Commonwealth Edison

April 18, 1983

Subject: Braidwood Station Units 1 and 2
Additional FSAR Information
NRC Docket Nos. 50-456/457

BRAIDWOOD STATION FINAL SAFETY ANALYSIS REPORT
FIGURE Q241.4-2 EXTERIOR DIKE PROFILE STA. 49+00 TO STA. 65+50

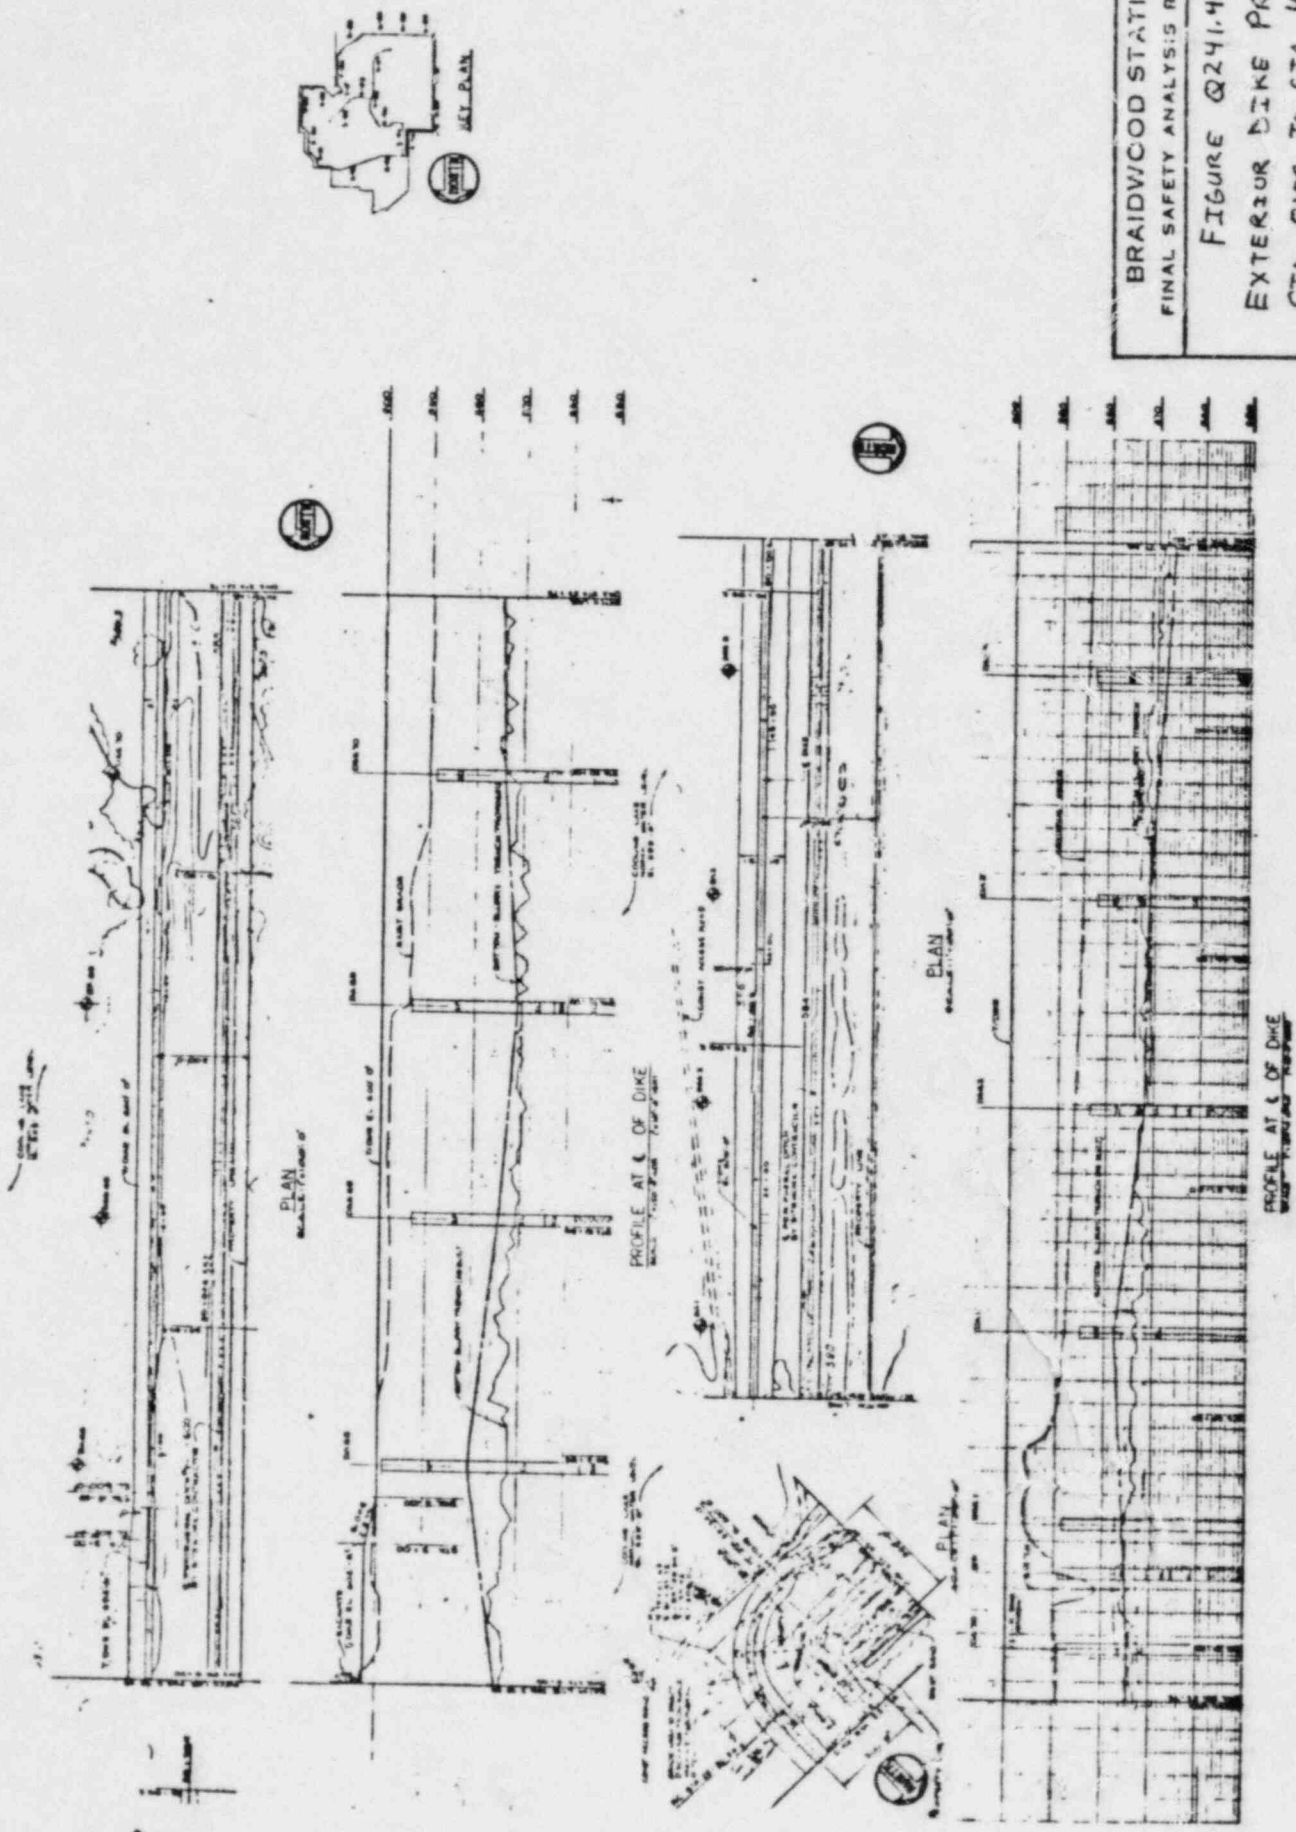
"The extent or limits of slurry trench cut off shown in FSAR Figure 2.5-74 does not agree with that described in the FSAR text (page 2.5-109). Explain this discrepancy. Also, provide a plan showing slurry trench cut off around the cooling lake and Essential Services Cooling Pond and verify that the slurry trench cut off is continuous and can be relied upon to act as a seepage barrier for the ESCP."

The slurry cut off trench beneath the perimeter dike system, referred to on page 2.5-109, is the slurry trench cut off for the perimeter dike of the cooling lake. A plan view showing the boundary of the cooling lake which coincides with the perimeter dike slurry trench is given in Figure 2.4-37.

The slurry trenches shown in Figure 2.5-74 are trenches that were installed prior to main plant and lake screenhouse construction to assist in construction dewatering of these facilities. These trenches are not considered permanent installations and should not be confused with the cooling lake perimeter dike slurry trench.

The cooling lake perimeter dike slurry trench is continuous around the perimeter of the cooling lake and, therefore, continuous along the north and west sides of the essential service cooling pond (ESCP). Plan views of the ESCP and perimeter dike along the north and west sides of the ESCP are given in Figures 2.4-26 through 2.4-29. Sections of the perimeter dike and slurry trench are given in Figure 2.4-35. The slurry trench along the ESCP is a soil-bentonite backfilled slurry trench extending from elevation 597 feet to top of till and, in most cases, are keyed into till. As-built profiles are provided in Figures Q241.4-1, Q241.4-2 and Q241.4-3.

The design of the ESCP does not rely on the slurry trench as a seepage barrier. The ESCP seepage has been conservatively determined assuming the slurry trench does not exist. Existence of the slurry trench only makes the seepage analysis more conservative.

FIGURE 2.4-7a

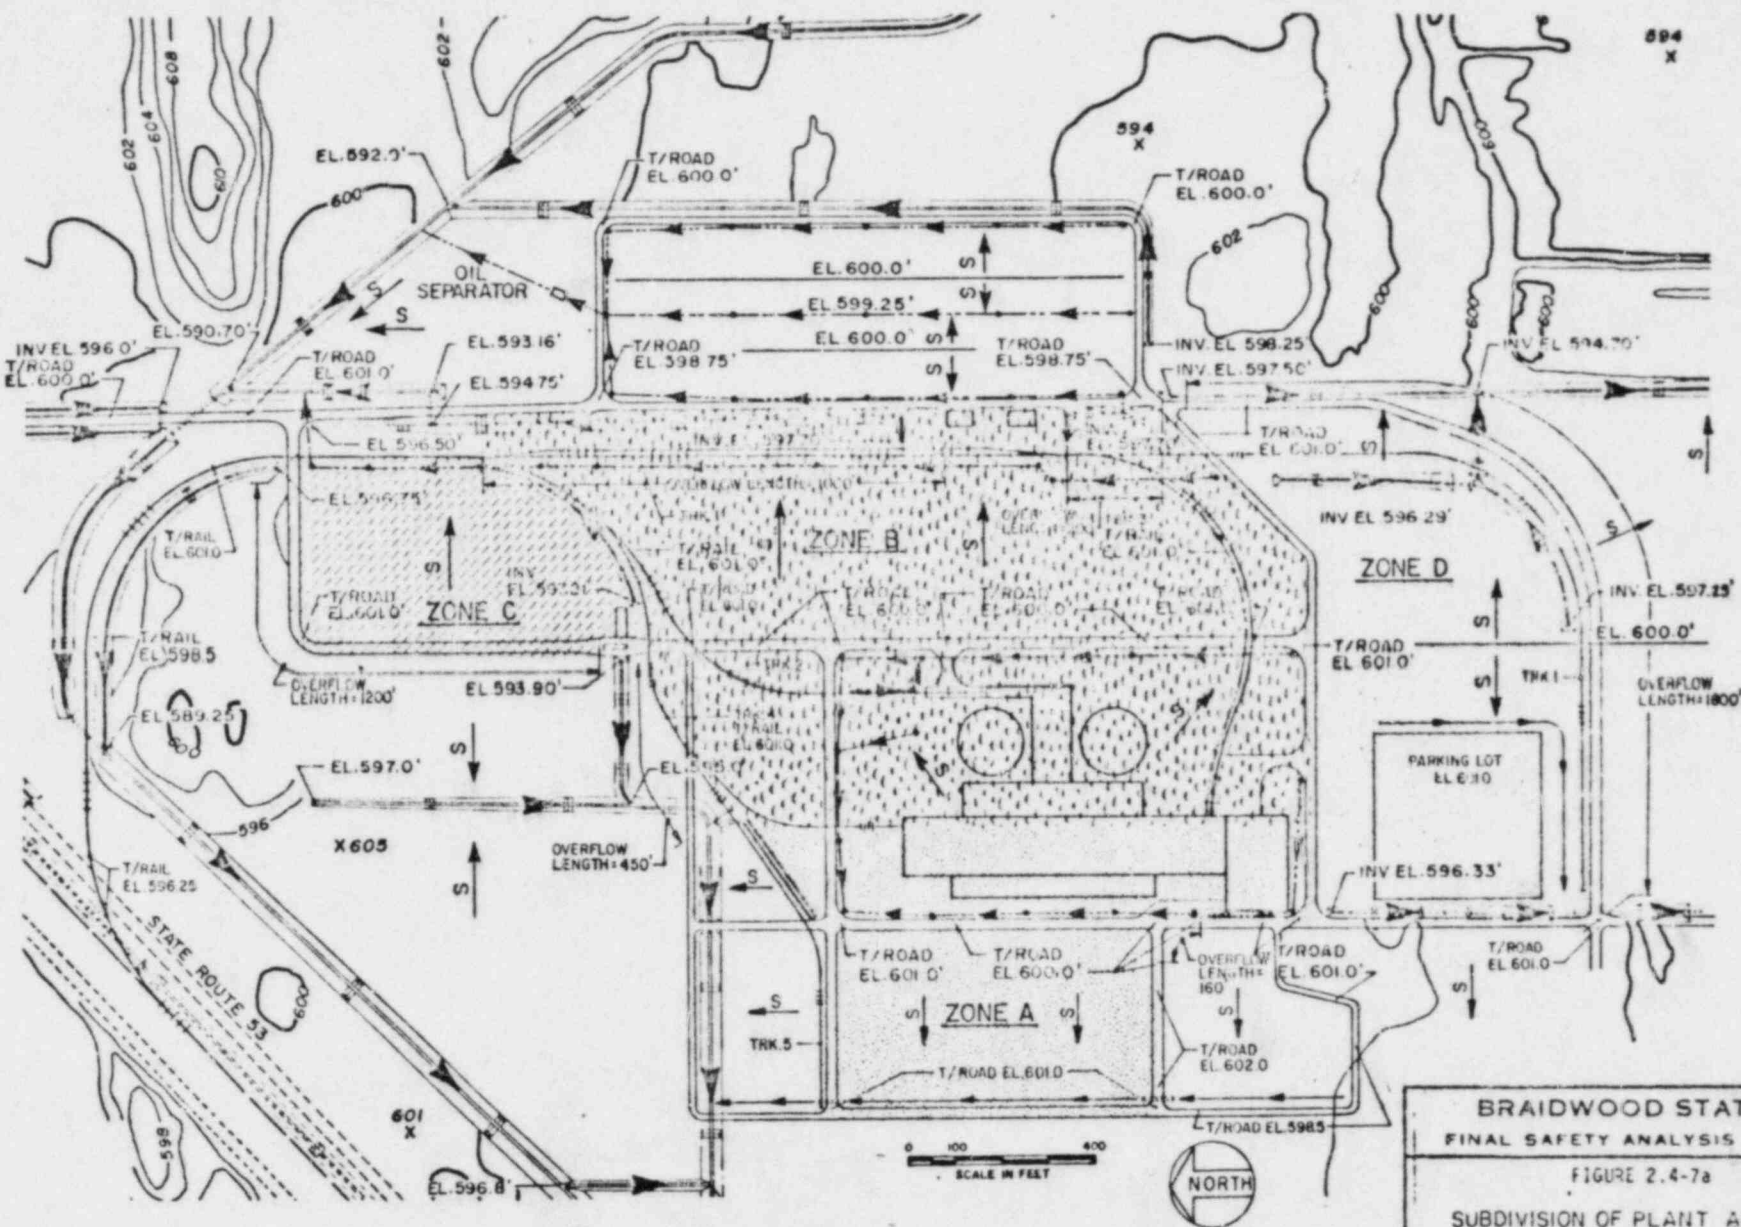
- (e) You state that area F will pond below plant flood elevations. Since you don't discuss routing or outflow, we must assume that the entire 48 hour PMP volume is stored, which would require about three feet of depth. Since ditch invert elevations are shown at 597.0, we don't think the volume is available. We need to discuss your methodology for this area."

The analysis for local intense precipitation has been revised. It is assumed that the site drainage system and the culverts will not be functioning at the time of local intense precipitation. The detailed description and results of the analysis are presented in revised Subsection 2.4.2.3.

The plant site area is divided into Zones A, B, C, and D as shown in Figure 2.4-7a.

The storm water, which accumulates in Zone A, flows over two peripheral roads southwest of the plant buildings. The overflow length of the road is approximately 160 feet at elevation 600.0 feet. The area of Zone A is 13.1 acres.

The weighted runoff coefficient is estimated as 0.69 and the time of concentration is 16 minutes. The peak runoff from Zone A is 285 cfs, which will flow over the peripheral road and would produce a water surface elevation near the plant buildings of 600.75 feet. If the value of runoff coefficient is conservatively assumed to be 1, the peak runoff from Zone A would be 413 cfs, with a water surface elevation of 600.97 feet near the plant buildings.

The runoff from Zone B flows over railroad track 1 on the east, and over track 4 on the north. The total overflow length as shown in Figure 2.4-7a is 1,550 feet, and the top of the rail is at elevation 601.0 feet for these two tracks. The area of Zone B is 27.3 acres. An estimated runoff coefficient of 0.63 was used, with a time of concentration of 20 minutes. The peak runoff from Zone B is 496 cfs, which will flow over the peripheral railroad and produce a water surface elevation of 601.23 feet near the plant buildings. If the value of the runoff coefficient is conservatively assumed to be 1, the peak runoff from Zone B would be 787 cfs, with a water surface elevation of 601.32 feet.
